**Report: TAB Report**  
**Function: Test, Adjust, & Balance**  
**Date: 05/29/2025**  
**Completed By: National TAB**

**PROJECT**  
**05-26-25 CAVA WARWICK, RI**

## Project Summary

## Issue List

**Issue Name :** 1. RTUs On Incorrect Curbs

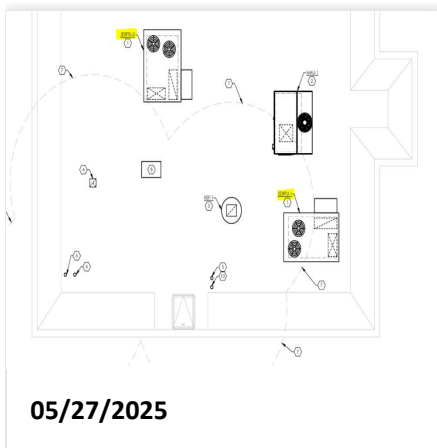
**Description :** The "48FCD09" unit is serving the Dining Area and the "48FCDN12" unit is serving the Kitchen. Per the mechanical plans, the larger unit is supposed to serve the Dining Area. To achieve proper cooling of the space, these units will need to be swapped.

- **05/27/2025 National TAB - Stephen Tassinaro**
  - Currently both units will be balanced to 400CFM/Ton respectively. This will not match the designs shown on the mechanical plans since there is now 4000CFM in the kitchen instead of 3400CFM. And 3400CFM in the dining room, instead of the original 4000CFM. All diffusers will be proportionally balanced.

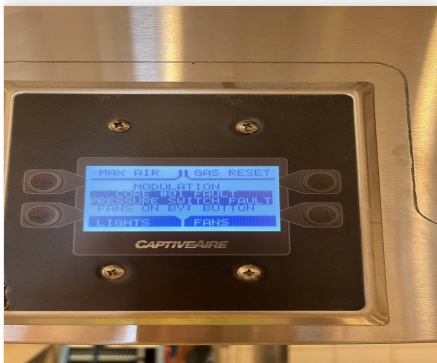
**Issue Name :** Grease Duct Not Secured to Curb  
**Description :** Duct top plate flanges to the edges of the curb, but it is not secured. This allows for movement of the grease duct and grease will accumulate.  
**Created By :** National TAB                      **Assigned To :** National TAB - Will Turnbough  
**Status :** Open  
**Priority :** Medium                                      **Asset Tag :**  
**Originated Date :** 05/29/2025 - Stephen Tassinaro - National TAB

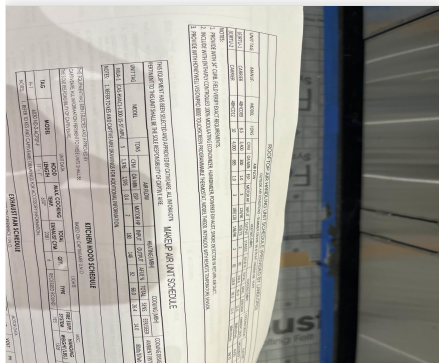
**Issue Name :** Humidity Sensors  
**Description :** There are no humidity sensors installed in the space. They are noted on M701, but locations are not shown. Recommend discussing with EOR to determine necessity and/or locations of these sensors.  
**Created By :** National TAB                      **Assigned To :** National TAB - Will Turnbough  
**Status :** Open  
**Priority :** InfoOnly                                      **Asset Tag :**  
**Originated Date :** 05/29/2025 - Stephen Tassinaro - National TAB
